Reference	SSM67677
Models	Range Rover (All New) / L405 Range Rover Sport / L494
Title	New Range Rover Sport & All New Range Rover Side Step Concerns Guide
Category	Accessories
Last modified	30-Aug-2013 00:00:00
Symptom	General Accessories
Content	<p><b>Concern</b> L405 or L494 one or more concerns with Accessory Deployable Side Steps (DSS):</p> <ol style="list-style-type: none"> <li>1. Dynamic Response Pipes contact Deployable Side Step Bracket.</li> <li>2. Free Play in Deployable Side Step Mounting Bracket</li> <li>3. Deployable Side Step Module Initialisation</li> <li>4. Deployable Side Step Fitting – Tap Hole Instruction</li> <li>5. Deployable Side Step Self-Test Procedure</li> </ol> <p><b>Action</b></p> <ol style="list-style-type: none"> <li>1. If it is noticed visually or audibly that the Dynamic Response Pipes are fouling the Side Step Bracket then please refer to TSB LTB00588</li> <li>2. If the front end of the Deployable Side Step is found to be loose when deployed, add 1 additional shim to the inner mounting point on the front of the bracket – See attached File – Side Step Extra Shim Fitment. PDF</li> <li>3. When conducting the initialisation procedure, should the Deployab

The screenshot shows the SDD interface with the following sections:

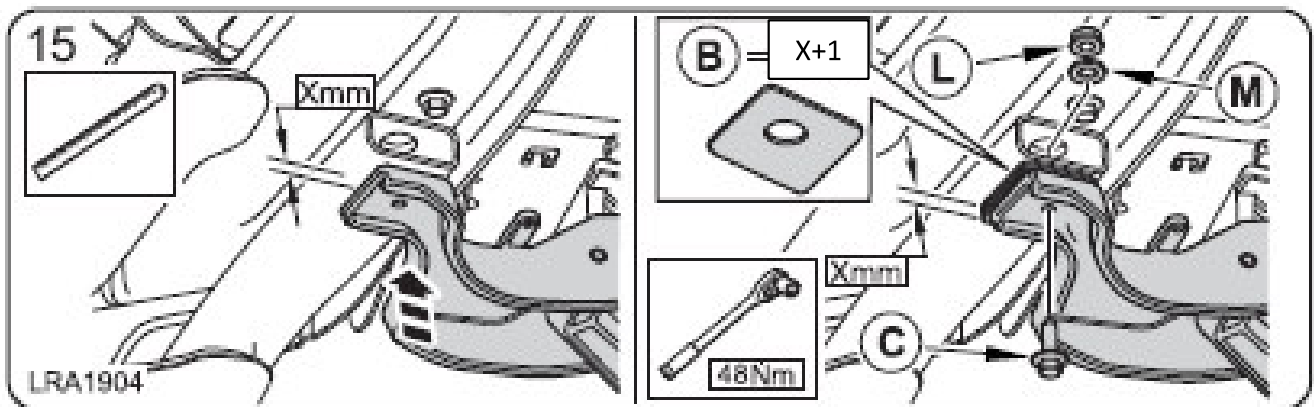
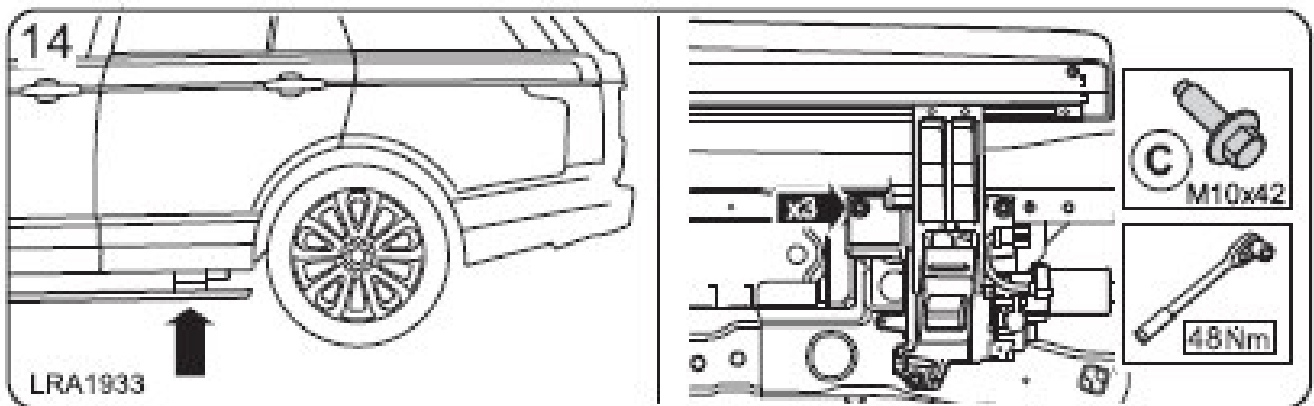
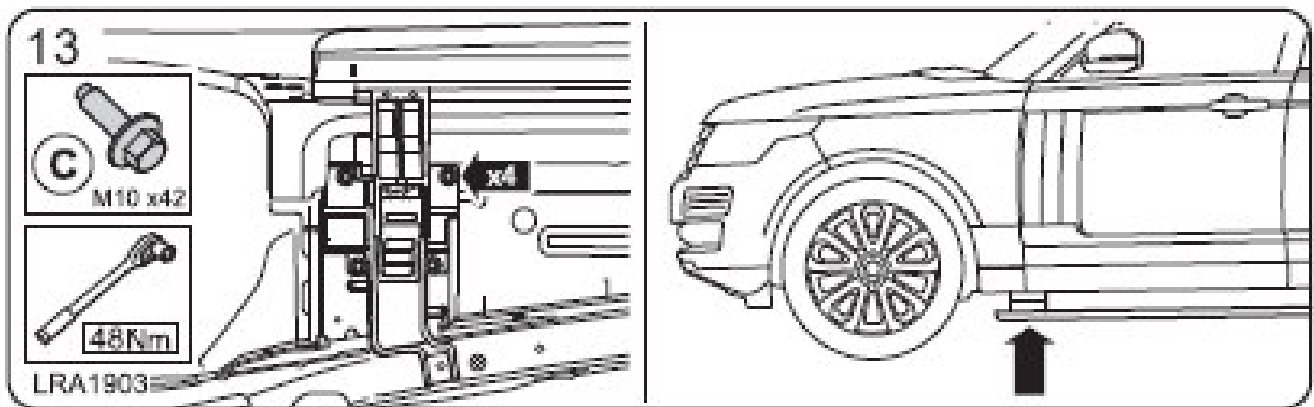
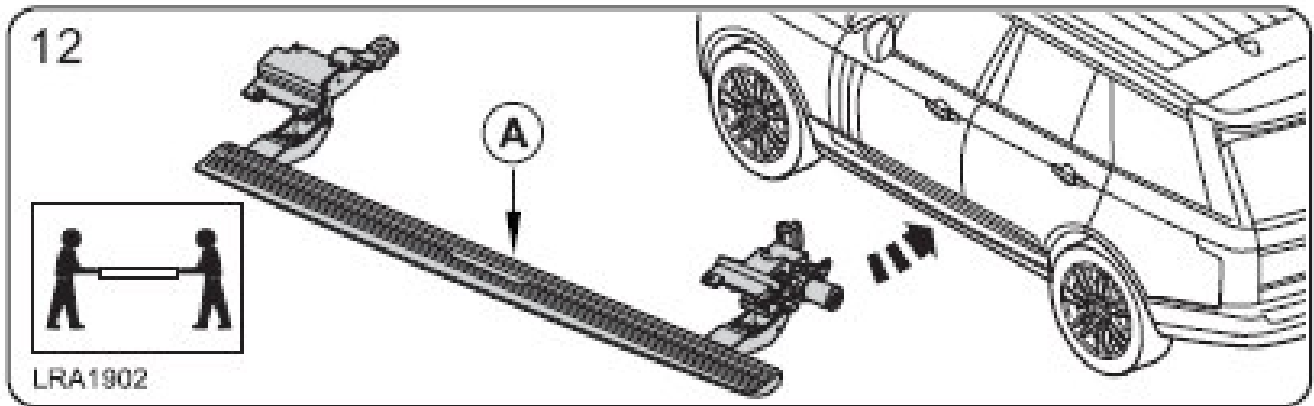
To access the self mode in SDD, under Deployable Running Boards navigate to the "Recommendations" tab where "General Diagnostics and Tools" will be visible and "Diagnostic - On demand self test - Running board control module" can be selected.

This routine will deploy and stow the left and right running board. During the deploy or stowing it evaluates the relay, current feedback, hall effect circuits and will drive the status LED active. The sequence of execution is: Stow Left (only if deployed upon entry into self test), Deploy Left, Stow Left, Stow Right (only if deployed upon entry into self test), Deploy Right, Stow Right, then LED test

If the module detects a fault during the exercise of this feature it will set or reset an active DTC. If there is no active faults after the test is complete, it should reply with a system pass message
